DART SERVICE INSTRUCTION

**TO AMEND INSTALLATION INSTRUCTIONS D350-591 REV. G
AND INSTRUCTIONS FOR CONTINUED AIRWORTHINESS ICA-D350-591 REV. 3**

**REF TCCA STC: SH92-6
REF FAA STC: SH967NE**

A	NEW ISSUE.	JPH	10.06.08
REV.	DESCRIPTION	BY	DATE
DESIGN		DART AEROSPACE LTD	
DRAWN		HAWKESBURY, ONTARIO, CANADA	
CHECKED		DRAWING NO.	REV. A
MFG. APPR.	N/A	DSI 9525	SHEET 1 OF 4
APPROVED		TITLE	SCALE
DE APPR.		STEP CUSHION CHANGE	NTS
DATE	10.06.08	COPYRIGHT © 2010 BY DART AEROSPACE LTD THIS DOCUMENT IS PRIVATE AND CONFIDENTIAL AND IS SUPPLIED ON THE EXPRESS CONDITION THAT IT IS NOT TO BE USED FOR ANY PURPOSE OR COPIED OR COMMUNICATED TO ANY OTHER PERSON WITHOUT WRITTEN PERMISSION FROM DART AEROSPACE LTD.

FIGURE 9: Crosstube Attachment
REF D350-591

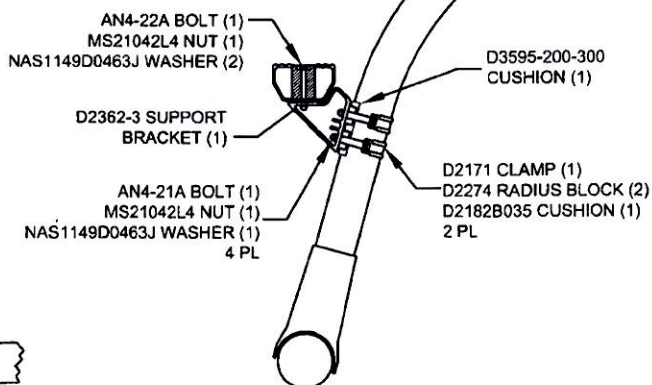
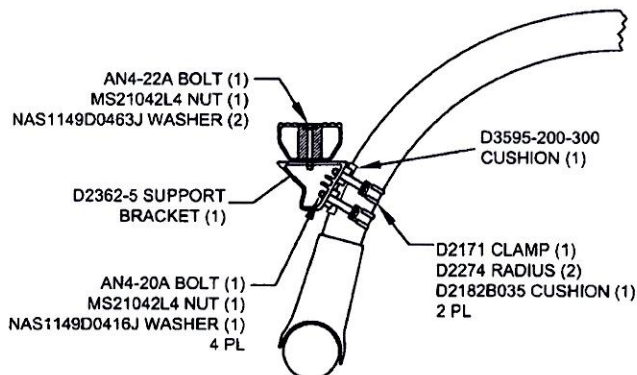
SECTION C-C: CENTER SUPPORT
(D350-591-111A ONLY)
(NOT TO SCALE)

SECTION D-D: AFT ATTACHMENT
(D350-591-111A/-113/-119 ONLY)
(NOT TO SCALE)

SECTION E-E: AFT ATTACHMENT
(D350-591-115 ONLY)
(NOT TO SCALE)

1. REMOVE THE STEP PER ICA-D350-591 SECTION 32.2
2. REMOVE THE D2856-400-720 ABRASION STRIP PER ICA-D350-591 SECTION 32.4
3. POSITION THE D3595-200-300 CUSHION AS INDICATED ON SHEET 3 OR 4 (AS APPLICABLE) OF THIS SERVICE INSTRUCTION.
4. REINSTALL THE STEP PER ICA-D350-591 SECTION 32.1 AS APPLICABLE USING THE NEW HARDWARE PROVIDED AS SHOWN ON SHEET 3 OR 4 (AS APPLICABLE) OF THIS SERVICE INSTRUCTION.

FIGURE 10: D350-591-117A Heli-Access-Step™, Pre-Flight Step
REF D350-591

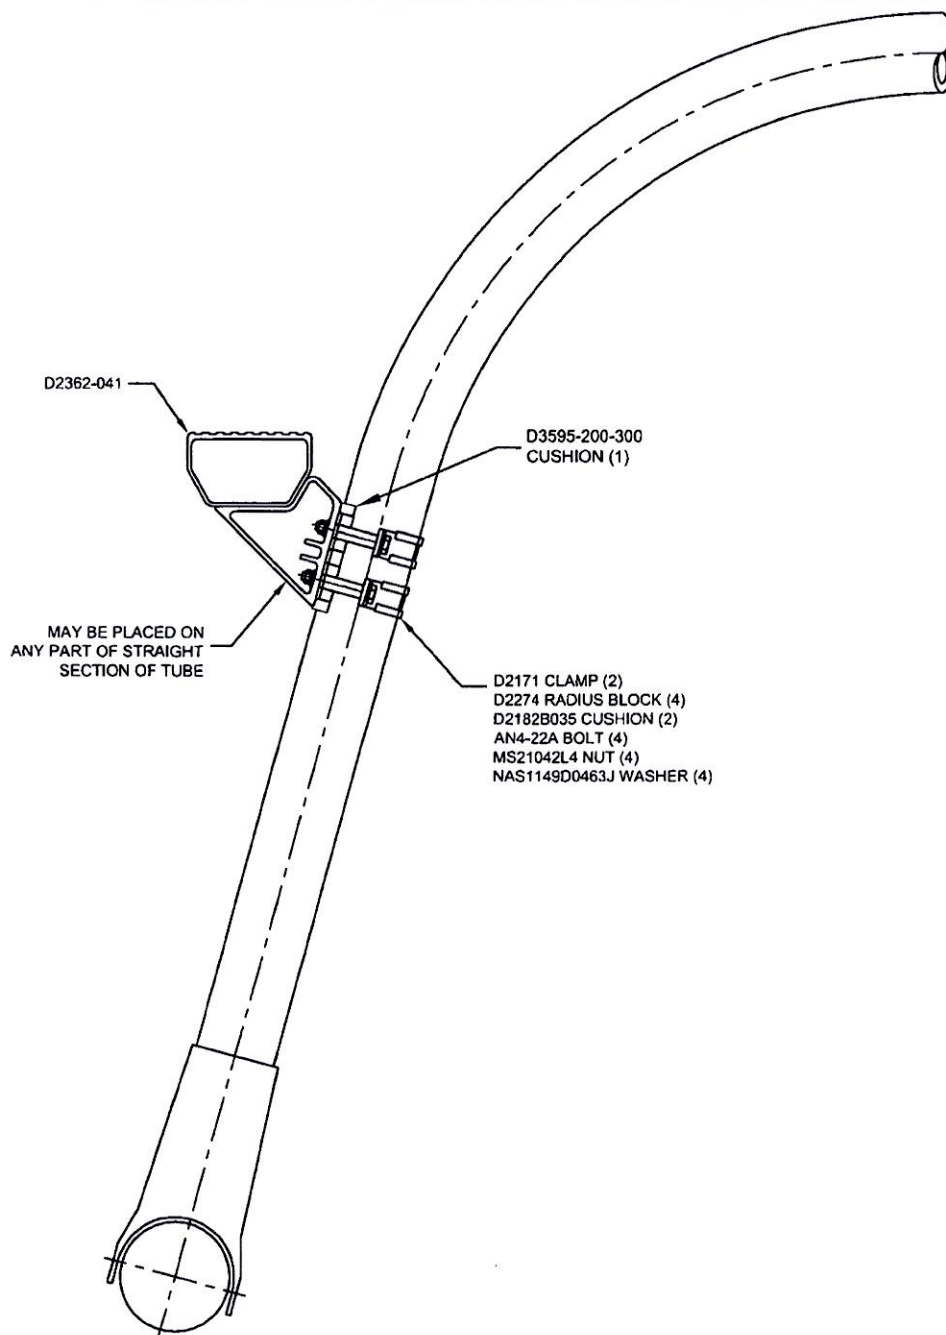
FIGURE 32-10: D350-591-117A Heli-Access-Step™, Pre-Flight Step
REF ICA-D350-591
